Additional Information Response
DUB11 CAMPUS DEVELOPMENT
Design Statement in support of
Planning Application

DUB11-DC-XX-G021-V1-PL-BMD

Revised Feb 28th, 2022

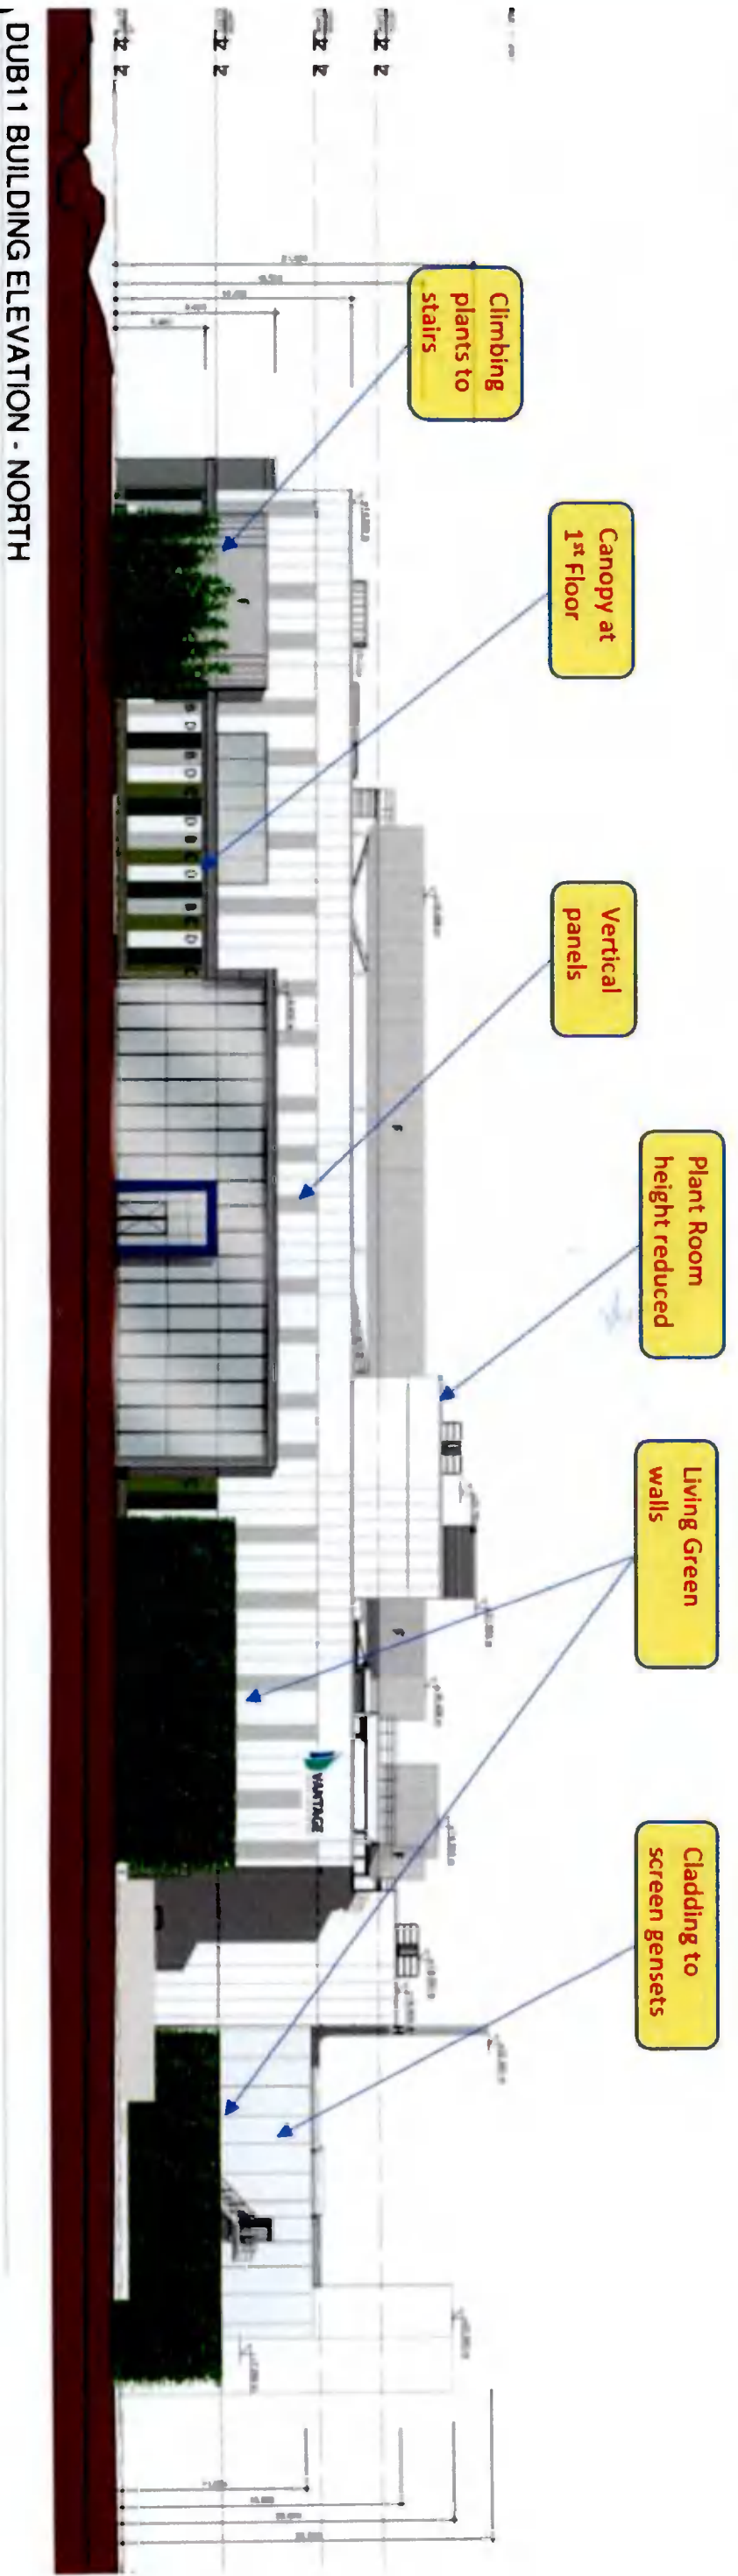
(b) The site is highly prominent, with significant blank facades.

- (i) The data centre buildings are significantly taller than the landscaping. The Planning Authority has significant concerns regarding the visual impact of this element of the proposal, given the prominence of the data centres along New Nangor Road and also within Profile Park, on Falcon Avenue. The applicant is, therefore, requested to consider how the visual impact could be reduced, in terms of both the design of the buildings, reduction in footprint of the buildings and also the provision of significantly additional green infrastructure and landscaping. The applicant is also requested to consider:
- Reorientating buildings to increase the visual prominence of active facades;
 - Redesigning buildings to reduce the monolithic appearance from New Nangor Road and Falcon Avenue;
 - Provision of further green walls.

Response

The detail design of the buildings was re-visited to address some of the other points raised by the Council and several changes made which are summarised below.

- Moving the offices to face the Road
- Changing the panel format to a vertical module.
- Lowering the height of the Plant Room
- Framing the cladding at the west end with projecting fascia

- Living Green Walls at Ground level
- Climbing plants on the mesh screen to the stair towers.
- Adding stronger colour to the panels
- Dark grey louvers to the chiller plant screen and the generator enclosure

DUB11 BUILDING ELEVATION - EAST

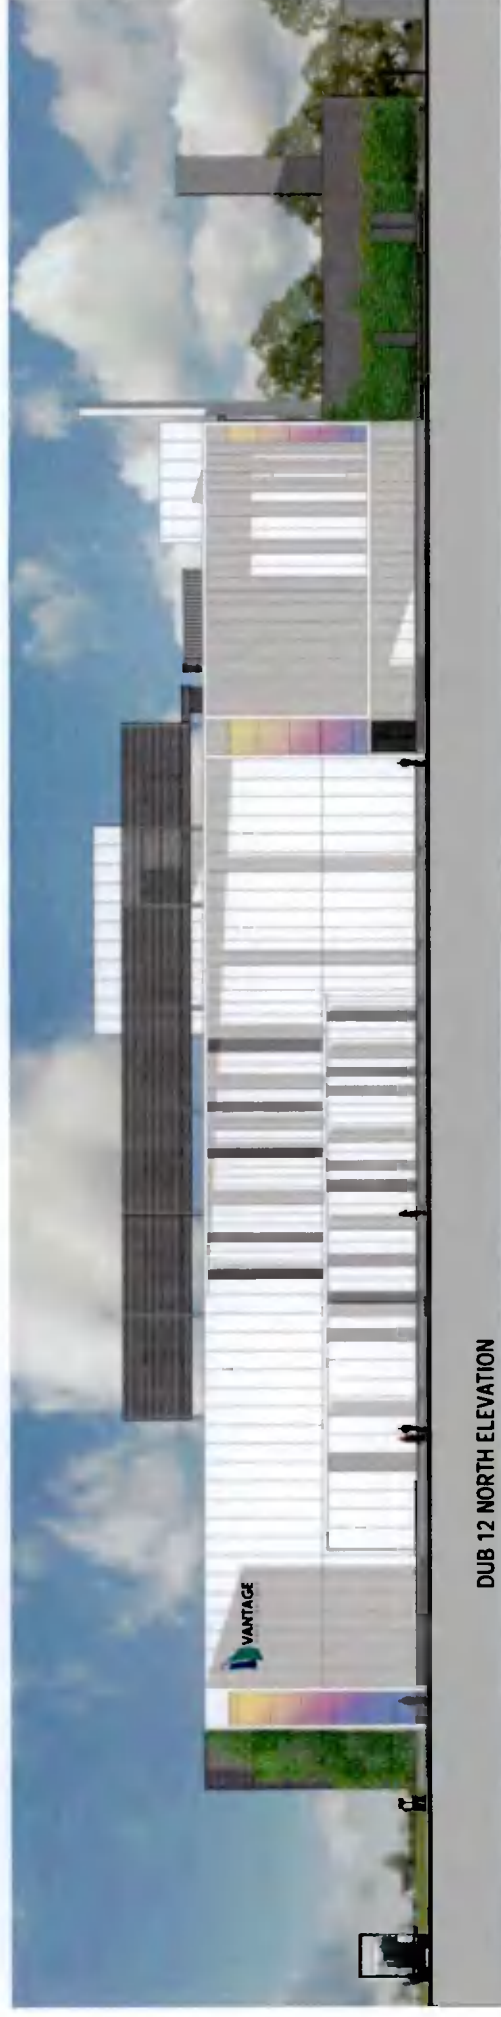
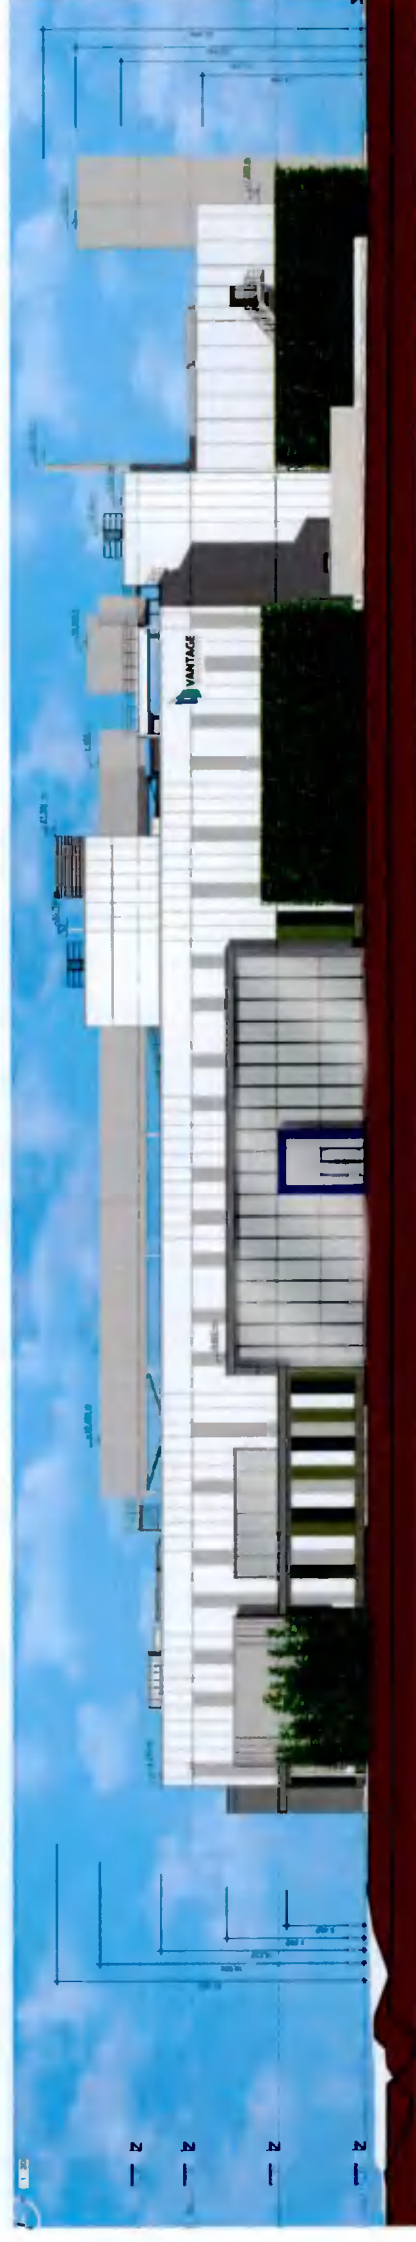
ORIGINAL APPLICATION – Elevation to New Nangor Road (Above) Blank frontage enlivened with coloured panels and trim. This softens the bulk of the building but a more substantial change is required to meet the Additional Information Request Point 3 (b)

The buildings have been re-organised on site to locate the main entrance of DUB11 facing New Nangor Road. This gives more visual interest and also affords staff and visitors an attractive view over the landscaped stream and berms. In addition, we have introduced living Green Walls in front of the loading bay and the generator compound. The wire trellises around the escape stairs are enlarged to allow climbing plants to flourish. By changing the means of escape from the roof to the staircase midway along the East façade we have reduced the escape stair on the NE corner to serve only the first floor. The overall level of the building is lowered by 250mm and the plant room on the roof reduced in height. The coloured panels on the façade are graded in colour from dark to light to reduce the visual bulk and a canopy has been added at first floor level to break up the massing from street level.

② DUB11 BUILDING ELEVATION - SOUTH

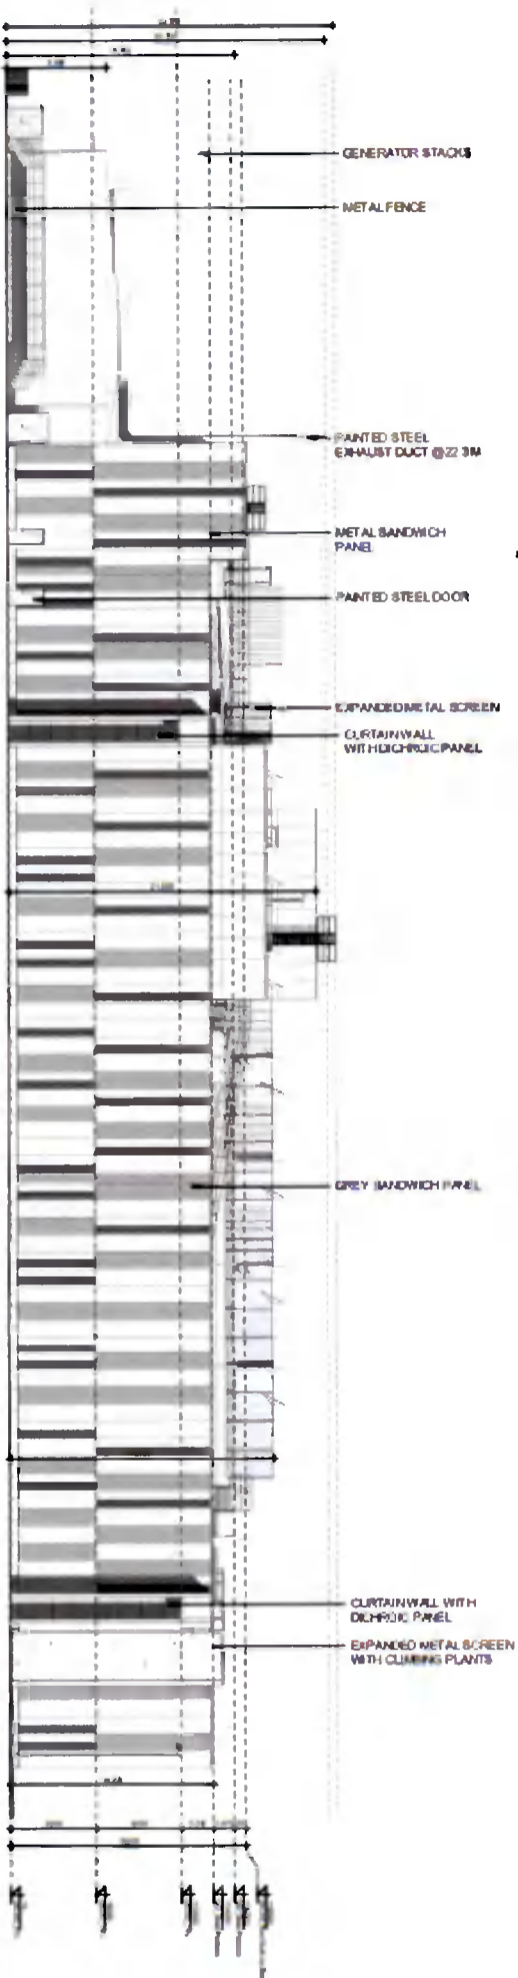
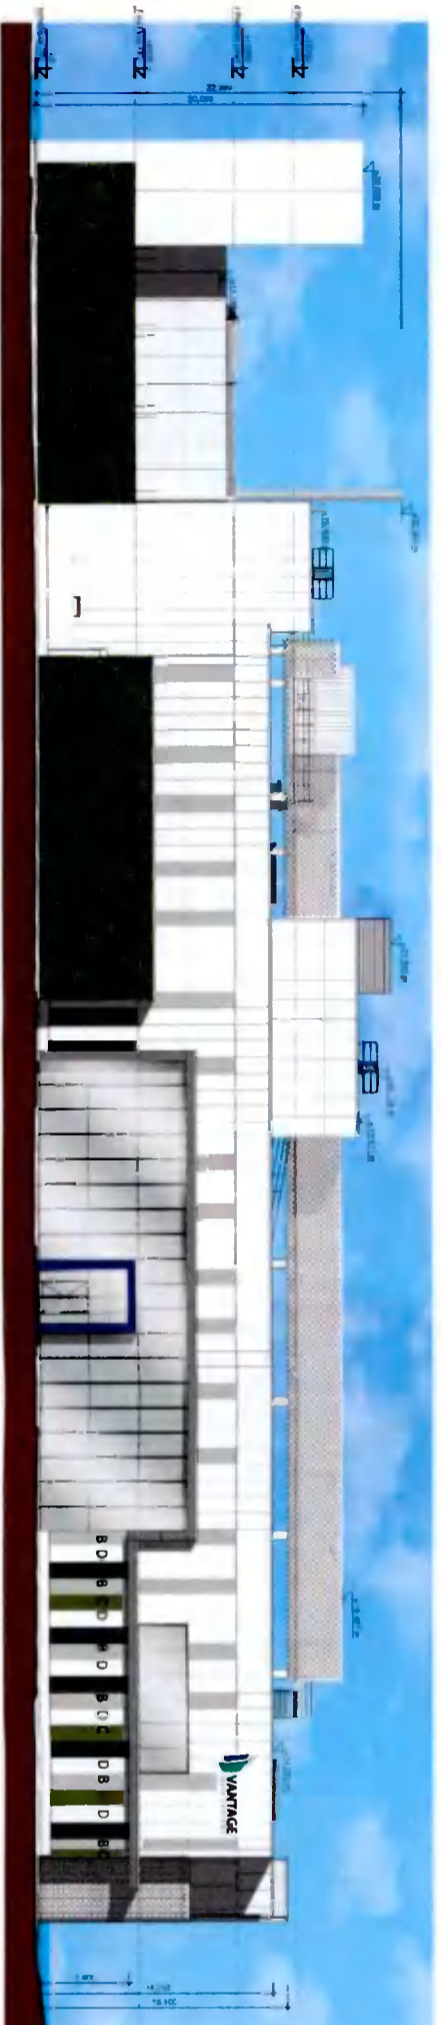
ORIGINAL APPLICATION – Elevation to Falcon Avenue (Above) Blank frontage enlivened with coloured panels and trim. This softens the bulk of the building but a more substantial change is required to meet the Additional Information Request Point 3(b)

The buildings have been re-organised on site to locate the main entrance of DUB12 facing Falcon Avenue. In addition, we have introduced living Green Walls in front of the loading bay and the generator compound. The wire trellises around the escape stairs are enlarged to allow climbing plants to flourish. The overall level of the building is lowered by 250mm and the plant room on the roof reduced in height. The coloured panels on the façade are graded in colour from dark to light to reduce the visual bulk and a canopy has been added at first floor level to break up the massing from street level.

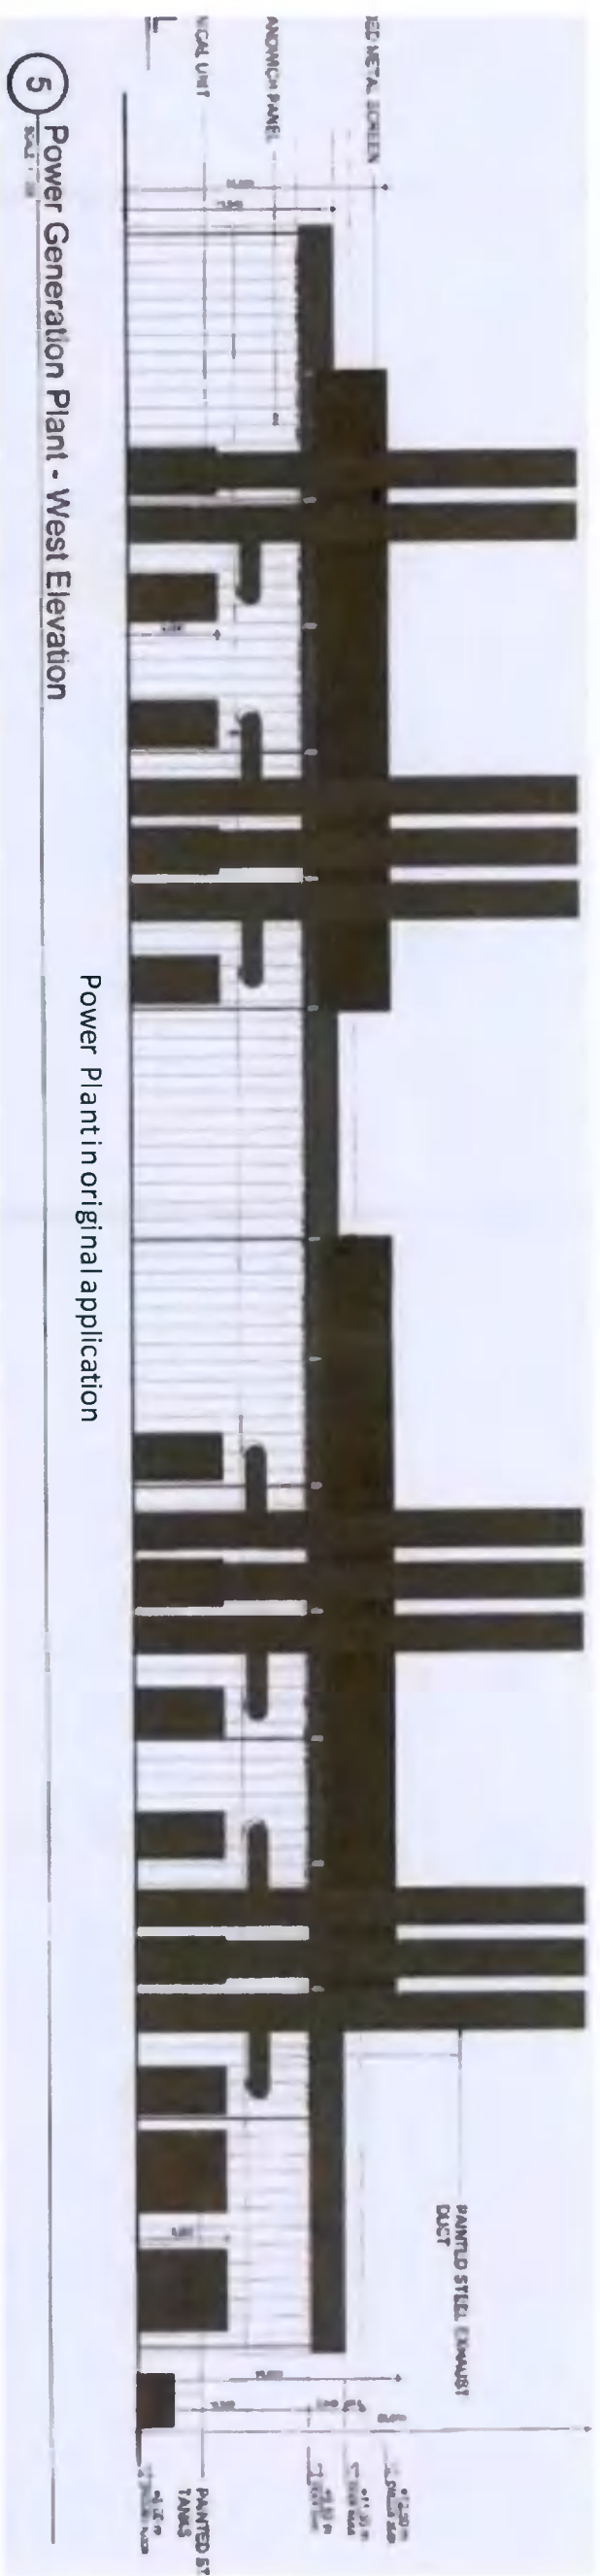
(iii) There are concerns regarding the design of the temporary power plant. It is noted that the proposal would be temporary, however, there are still concerns regarding the presence of significant blank facades. The floorplans provided indicate a single access gate to the north and south and it is noted that these details are not reflected on the elevations. The Planning Authority request that the applicant consider adding detail to these elevations, to reduce the monolithic appearance.

The evolution of the Energy Strategy described in the Planning Consultant's Report means that the temporary power plant is no longer required and is omitted from this Additional Information package.

5 Power Generation Plant - West Elevation

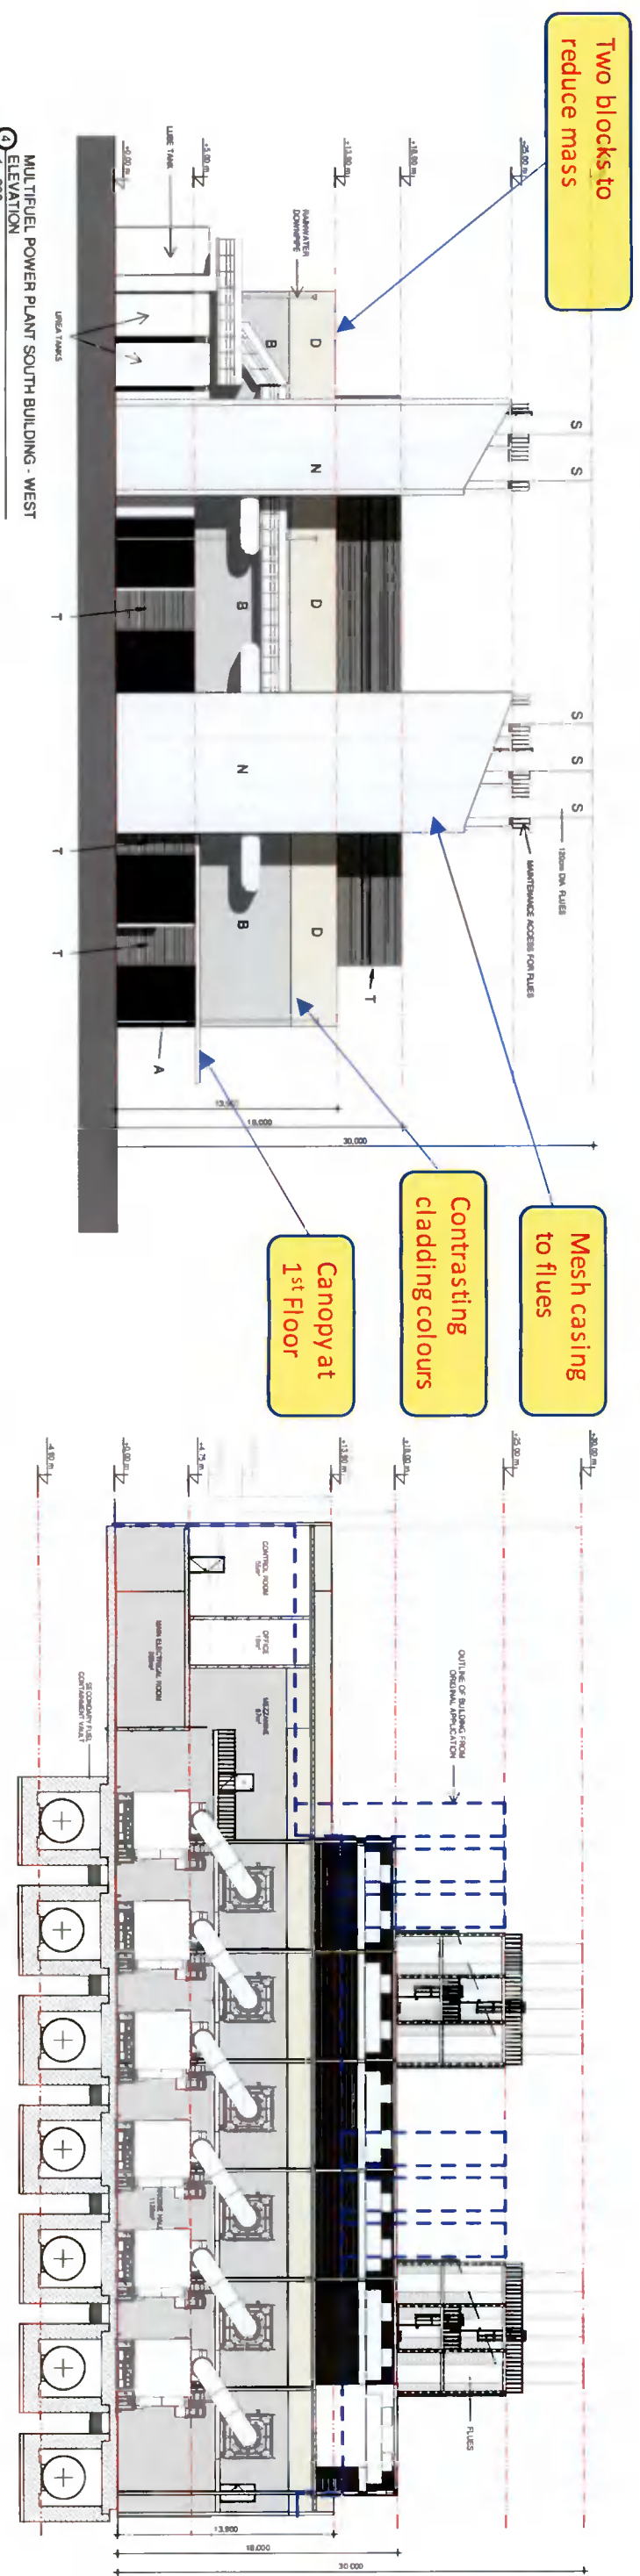
(ii) The permanent power plant would be over 118m long and would have a significant presence on the western boundary of the site. It is noted that the western elevation is blank and monotonous, with flues. Whilst significantly shorter than the west elevation, the south elevation also appears blank. The Planning Authority request that the applicant consider adding detail to these elevations, to reduce the monolithic appearance.

The multifuel Power Plant is now split into two buildings separated by the Step-up Transformer compound. The North building is 63m long and the South building is 46 m long, with a separation of 40 metres. Whereas on the original scheme the Substation faced onto Falcon Avenue, it is now almost hidden between the two Power buildings.

This page shows the changes made to the design of the Power Plant to reduce mass and bulk and enhance the appearance.

Revised Scheme looking northeast from Falcon Avenue

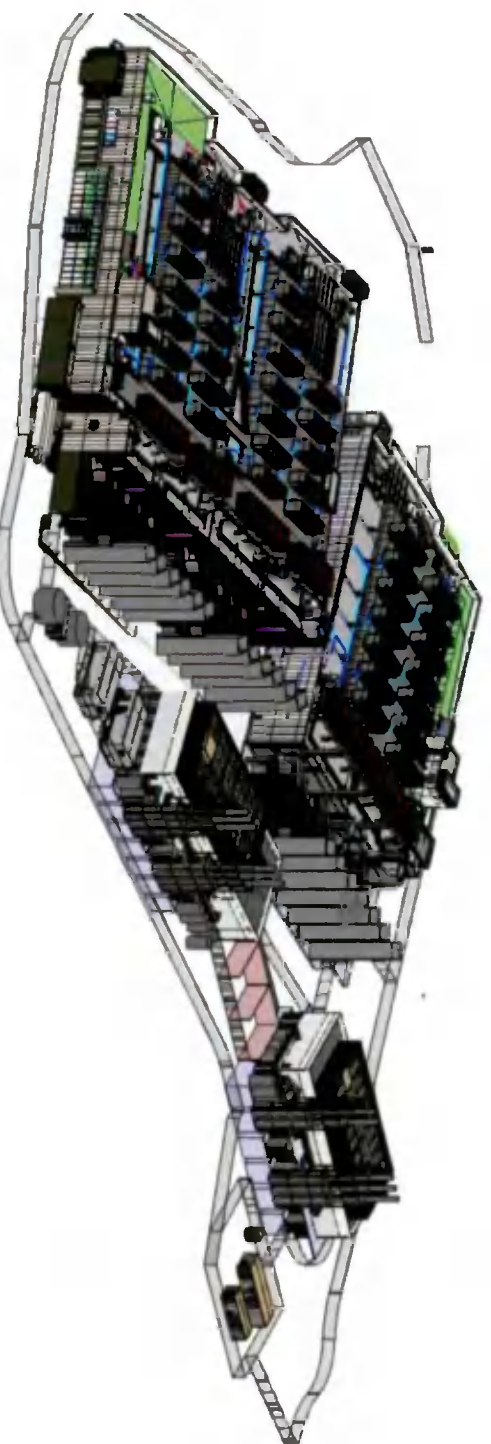
(g) there are a number of inconsistencies within the photomontages. The applicant is requested to provide the following:

- Location of view 1
 - Proposed views for view 4 and 8
 - Details of locations for 7a and 7b
- It is noted that the proposed development would take place in a number of phases. The applicant is requested to provide photomontages which reflect the different phases. These should include an interim landscaping. It is noted that earlier phases may be in place for a number of years prior to the construction of later phases. All boundary treatment and landscaping should be included in the photomontages.

All of the photomontages submitted with the original application have been updated to reflect the revised site layout and building façade treatments as well as the new landscaping layout. Views are included in the EIR Volume 2 Technical Appendices prepared by Ramboll Engineers.

The Design Statement includes photomontages of the new scheme compared with the original scheme to demonstrate the effort to reduce the visual impact of the design.
